MFN 253-95  
Docket No. 52-004

Subject: SBWR - Non-Proprietary Version of RAI Responses Submitted May 31, 1994

Purdue RAI Set 4

### FLOW PATH FOR DRYER (SEE QUESTION # 3)

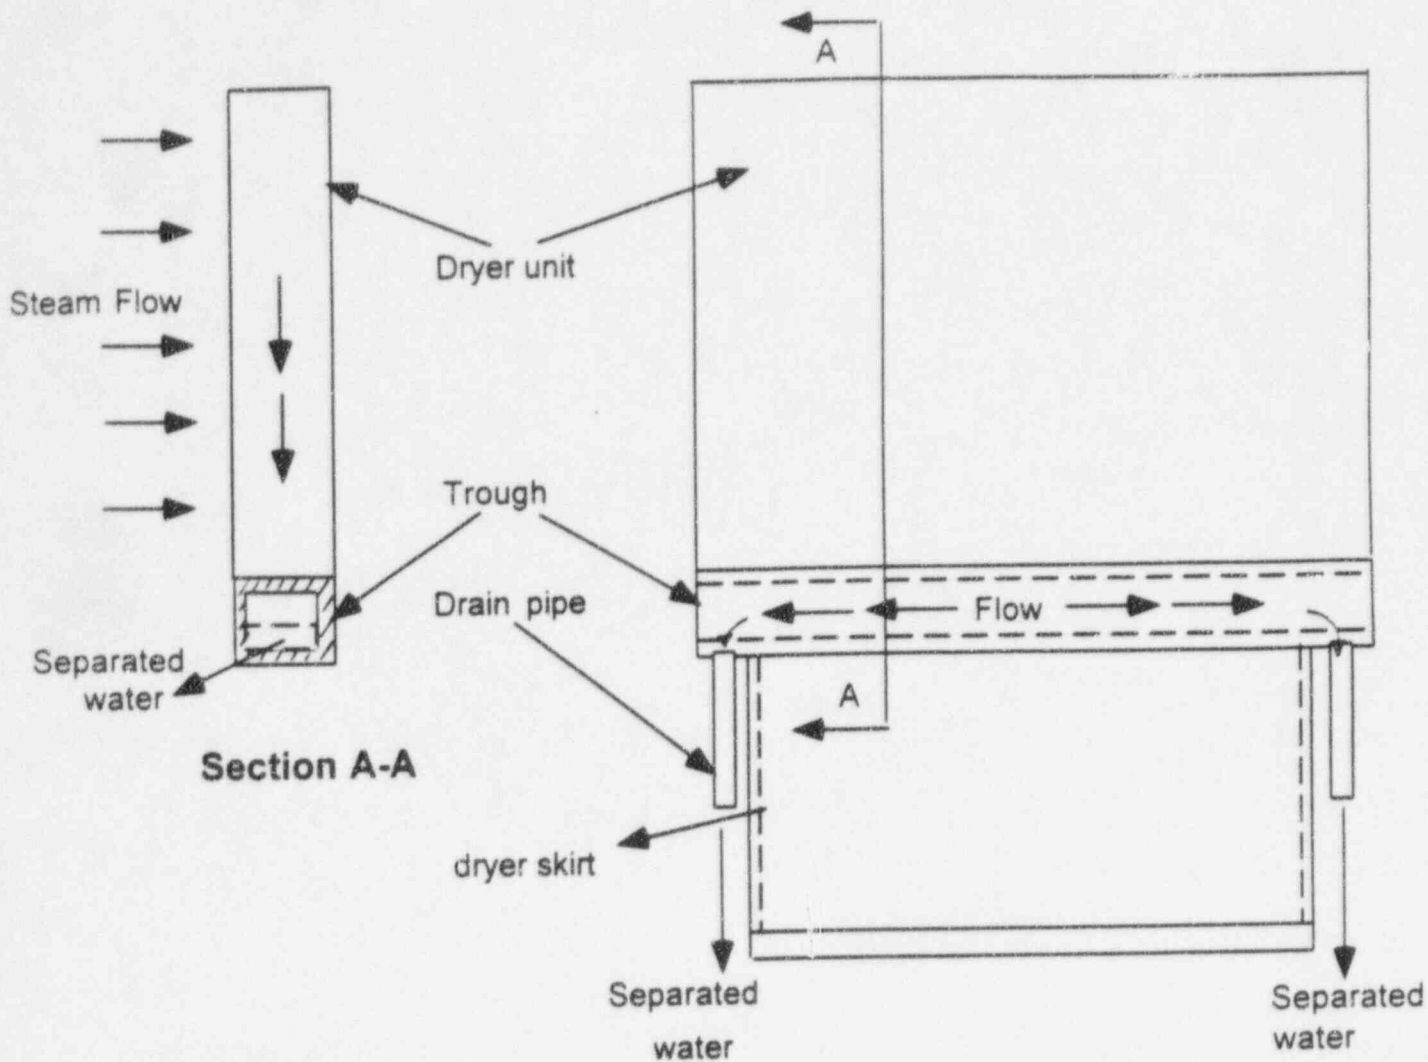
Provide the dimensions for the inside diameter and the outside diameter of the dryer skirt and the corresponding elevations of the dryer. Provide a clear picture of the flow paths for water collected in the dryer troughs to return to the downcomer annulus through the pool surrounding the steam separators. What are the flow area and clearance in the annulus between the dryer skirt and vessel inner wall (at the elevation of a main steam line)?

The dryer skirt inside and outside diameters and the corresponding dryer elevations are provided in References 1 and 2. The attached figure titled, "Flow Path for Dryer" shows the flow path for water collected in the dryer troughs, for return to the downcomer annulus through the pool surrounding the steam separators. The flow area and clearance in the annulus between the dryer skirt and vessel inner wall, at the elevation of the main steam line, can be determined by using Reference 2.

Flow Path: Steam from the separators pass through the dryer units where dry steam is separated, and flows upward. The separated water is collected in the troughs, flows outward to the drain pipes, and down to downcomer region.

# Feedwater Line Break Area Calculation (Response No. 13)

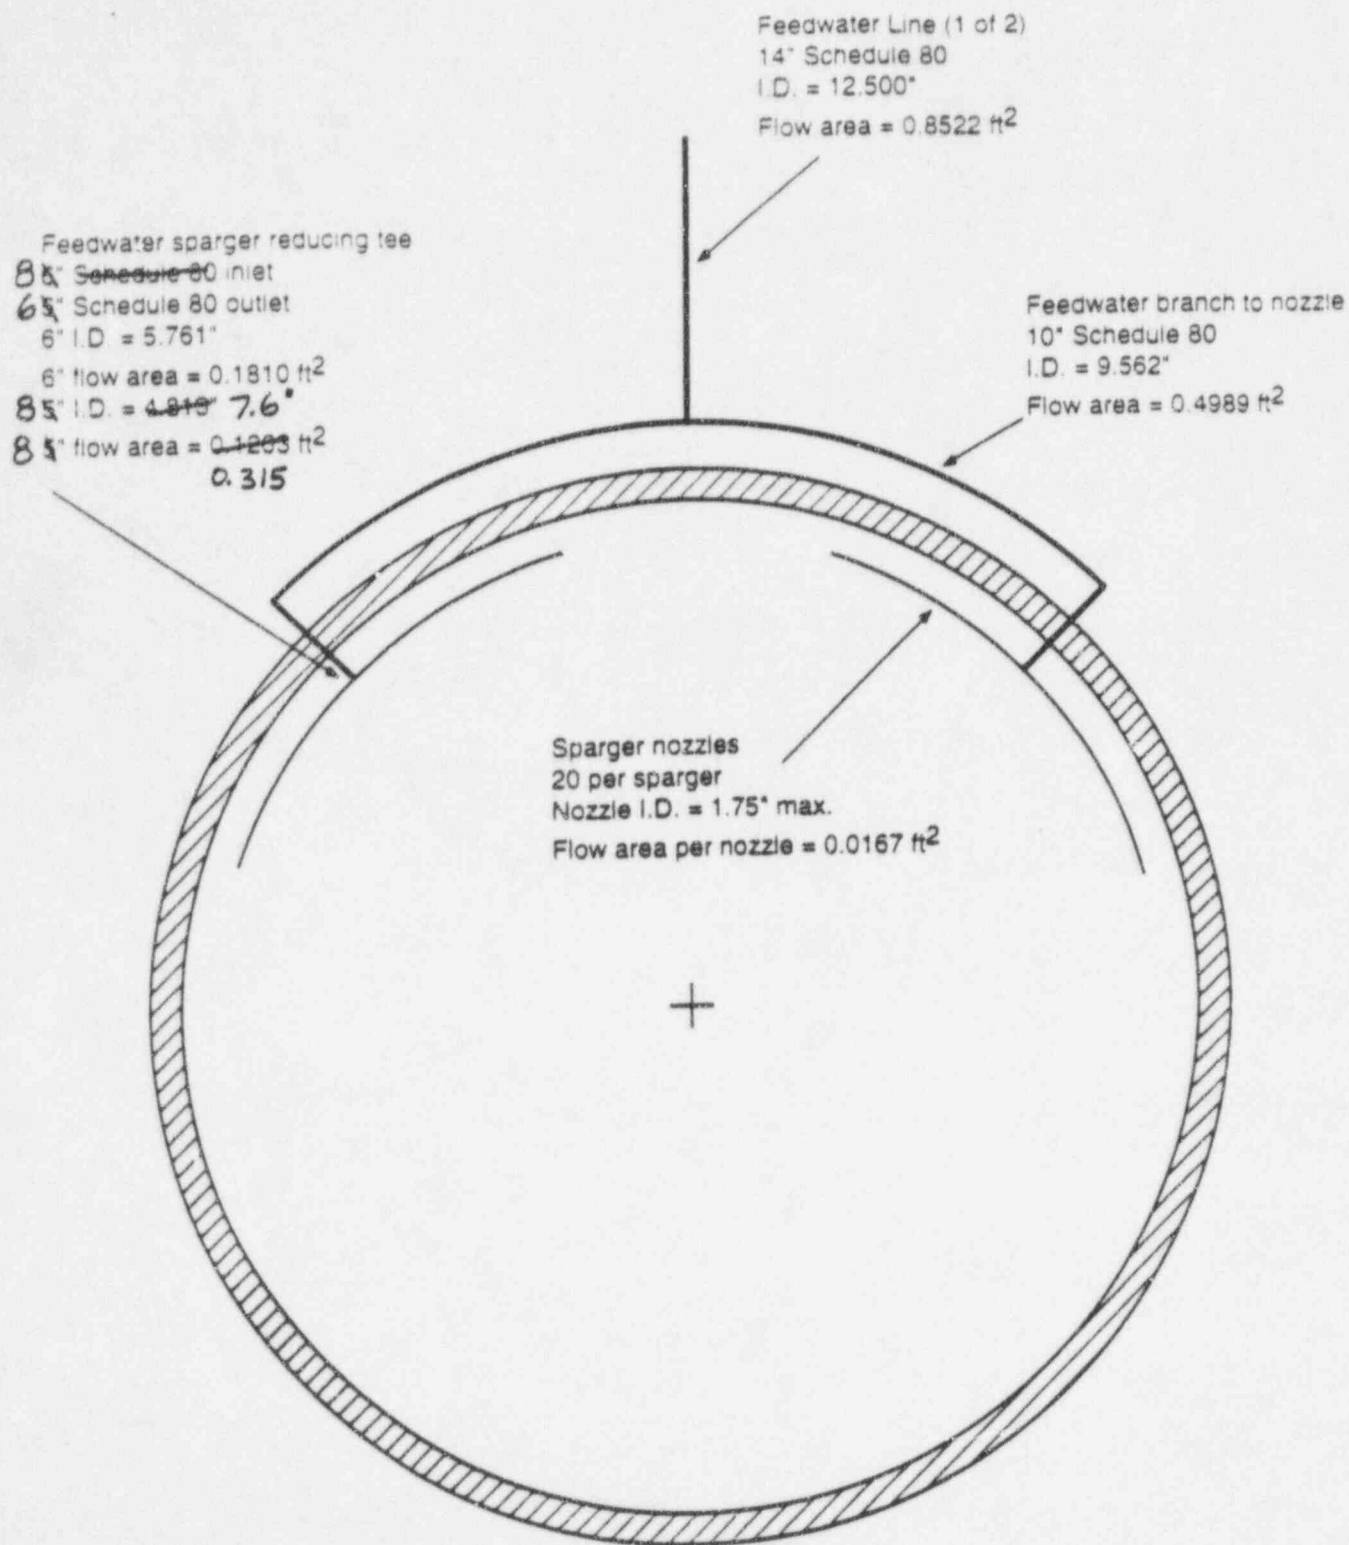
On page 6.3-20 of the SSAR, the feedwater line break size was listed as 8.9 in (inside diameter equivalent nozzle size). However, the pipe at the reactor pressure vessel penetration is a 10-inch Schedule 80 pipe with an inside diameter of 9.5 in. What is the correct break size for the feedwater line break?

The feedwater sparger details were previously provided in the response to question 1a of the first set of Purdue Questions. In order to reduce the fatigue stresses at the feedwater nozzle thermal sleeve, the design of the thermal sleeve and sparger has been revised. The figure that was included in the responses to the Set 1 questions has been revised and it is included with these Set 4 responses.

With the new design, the limiting feedwater line break area is 0.630 ft<sup>2</sup>. For further details, refer to the attached figure titled, "Feedwater Line Break Area Calculation".

14" feedwater line	1 line	0.852 ft <sup>2</sup>
10" feedwater branch to nozzle	2 lines	1.00 ft <sup>2</sup>
8" Tee inlet	2 lines	0.630 <del>0.382</del> ft <sup>2</sup>
6" Tee outlet	4 lines	0.724 <del>0.504</del> ft <sup>2</sup>
Sparger nozzles	40 total	0.668 ft <sup>2</sup>

Conclusion - Limiting break area =  $\frac{0.630}{0.382} \text{ ft}^2$
